VERNON RANCHETTES, LOT 1, AP (SCUSSEL) FOUR-LOT MINOR SUBDIVISION

STAFF REPORT FOR PLANNING BOARD

Channel through Scussel property Worksheet for Trapezoidal Channel

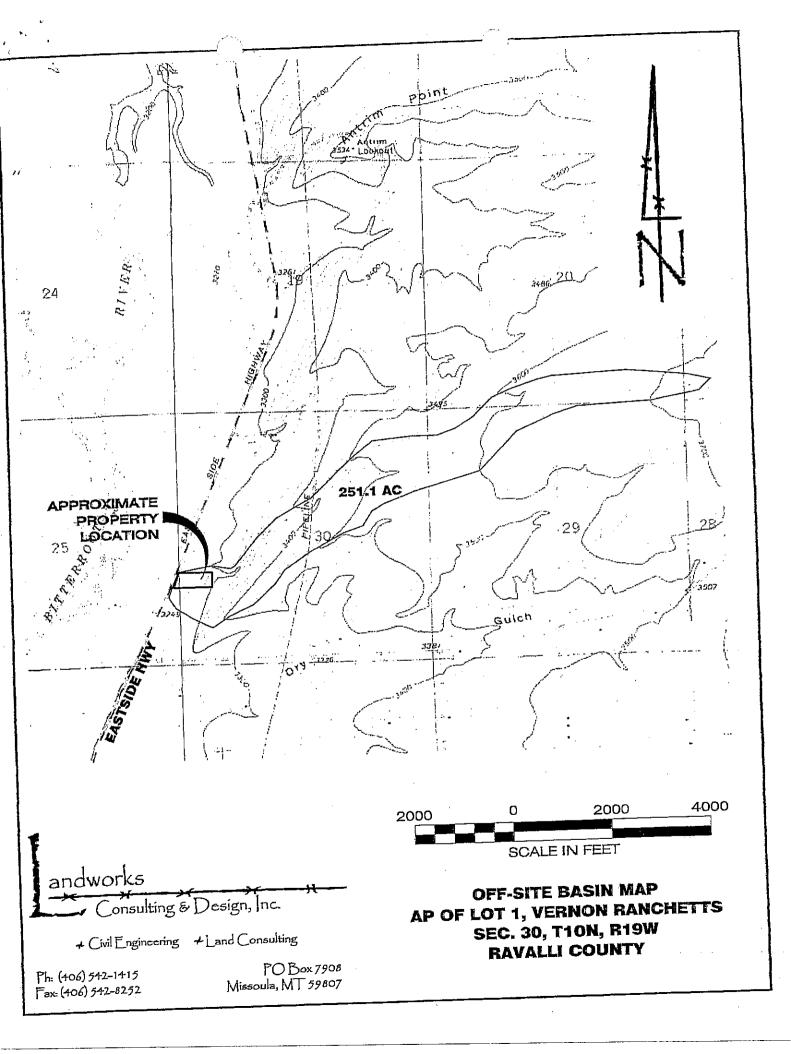
- 1) Larger diameter rock will be required for the check dams in order to better maintain their integrity. 4-inch to 6-inch diameter "sump" rock is recommended.
- 2) The drainage report indicates "large off-site storm water flows are not expected." From preliminary review of the USGS map, it appears that the drainage-way that runs through the site drains a relatively large upstream basin. Please provide a USGS map of the basin upstream and downstream of the site; corresponding design calculations to determine the extents of the 100-year storm through the site, in order to protect a future home site; and any mitigation measures necessary to manage construction of a future home site, sheds, etc. with the flow path of the 100-year runoff.

2. A USGS map is attached showing the upstream and downstream drainage-way that runs through the property. The Rational Method design calculations for a 100-year storm event of the upstream and downstream basins indicate a total flow of 50.72 cfs through the drainage way. The drainage-way through the property is a minimum of 45 feet wide. In a 100-year storm event, Flowmaster calculations show a channel depth of 0.28 feet for 50.72 cfs of flow. In the unlikely event that a homeowner would choose to build a house in the drainage way, standard building practices elevate a homesite a minimum of 0.5 feet above the surrounding ground to provide for positive drainage away from the structure. These standard practices would sufficiently elevate the homesite above the calculated 100-year flow depth, which will prevent a home from being inundated in such an event. The drainfield is not proposed within the drainage way.

Drainage Ba	
	ısin
100-Year, One-hour Event C x i(in/hr) x Area(ac) 50.72 cfs
